Mr. A. Schwencer, Chief  
Licensing Branch No. 2  
Division of Licensing  
U.S. Nuclear Regulatory Commission  
Washington, DC 20555

SUBJECT: Limerick Generating Station, Units 1 & 2

REFERENCE: Meeting between Containment Systems Branch (CSB)  
Reviewer, Mr. F. Eltawila, and Philadelphia  
Electric Company on April 7, 1983

FIGURE 3.11-3

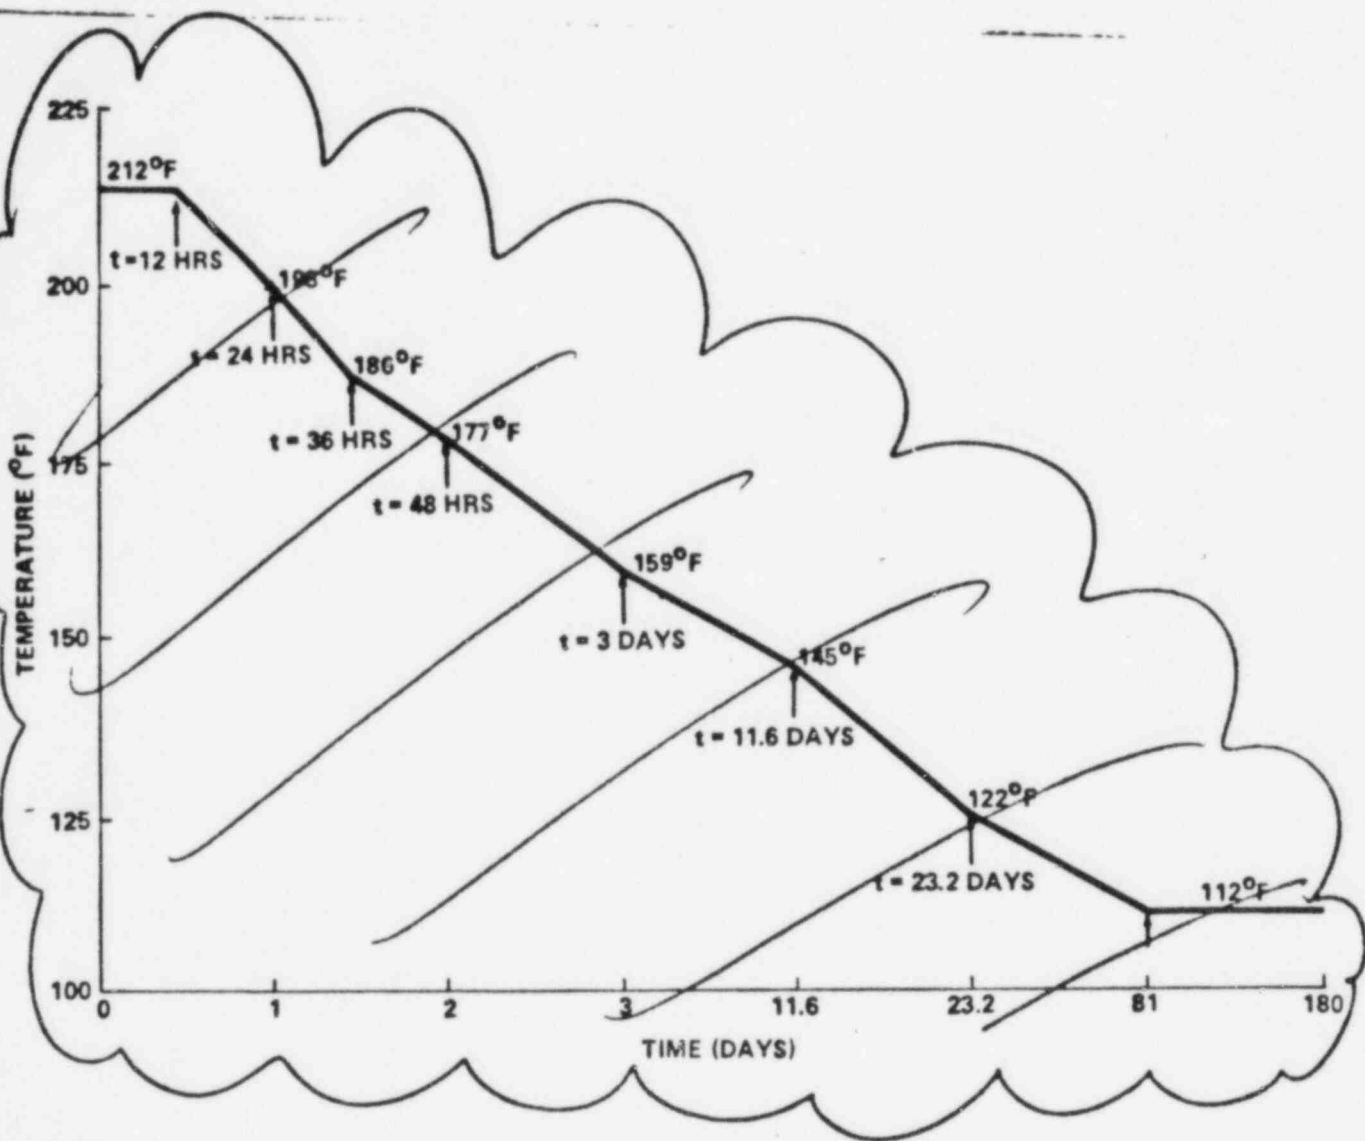
- Main steam line break in main steam tunnel
  - RHR steam line break in RHR compartment
- LOCA temperature profiles as a function of time are provided in Figure 3.11-3 through Figure 3.11-6. For areas without LOCA temperature profiles, assume the maximum temperature lasts 180 days. The isolation valve compartment HELB temperature profile as a function of time is provided in Figure 3.11-7. Areas which have maximum HELB temperatures listed, but do not have HELB temperature profiles, only contain components which will have completed their safety function once the blowdown has ceased, which in all cases is significantly less than one minute. The maximum temperatures listed for the control structure are maximum LOCA temperatures. Maximum temperatures resulting from other accidents will be evaluated later.

The revised section and figures are attached.

FIGURE 6.2-36

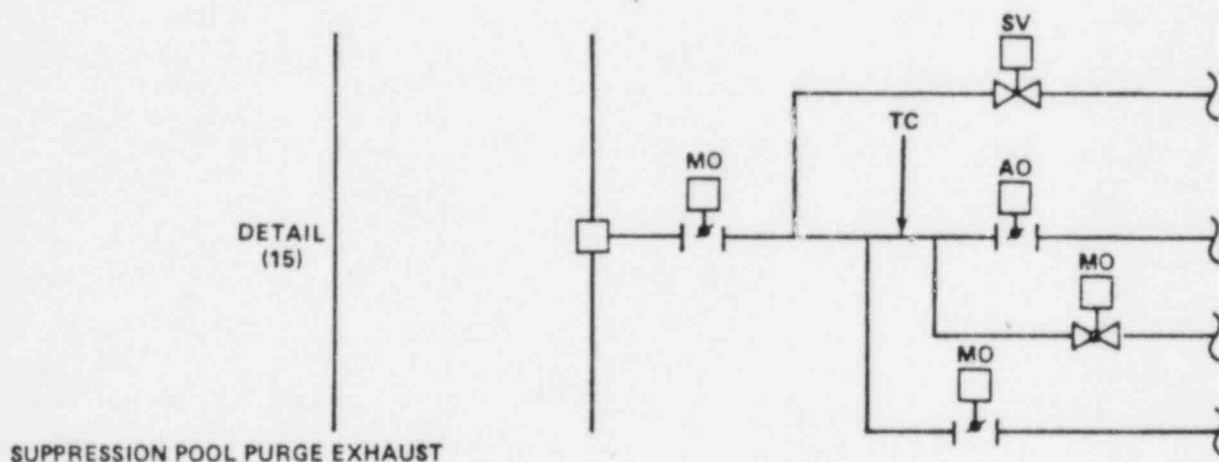
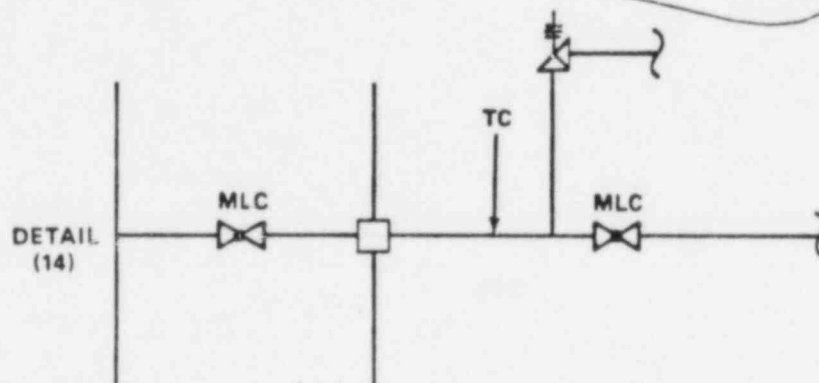
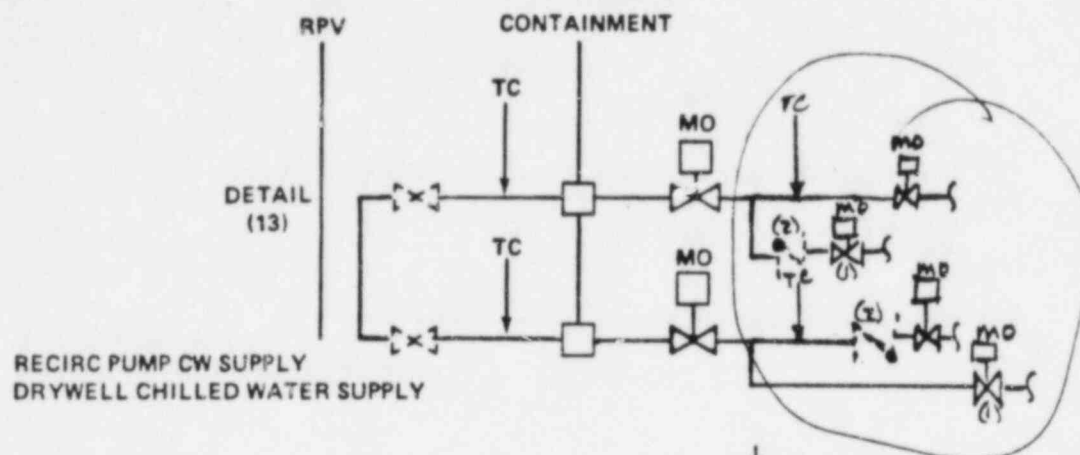
Because the systems inside containment to which the recirculation pump cooling water supply and return lines and the drywell chilled water supply and return lines connect are not closed systems (i.e., not Safety Class 2 and/or not seismic Category I and not protected against missiles and pipe whip) the containment isolation design of these penetrations must be revised to meet GDC 56 requirements. The applicant's response to NRC Question 480.40 has not resolved this open item. (Open Item)

The containment isolation system designs of the drywell chilled water system and the reactor enclosure cooling water system have been revised to meet the requirements of GDC 56. The following Sections, Tables, and Figures have been revised accordingly and are attached.
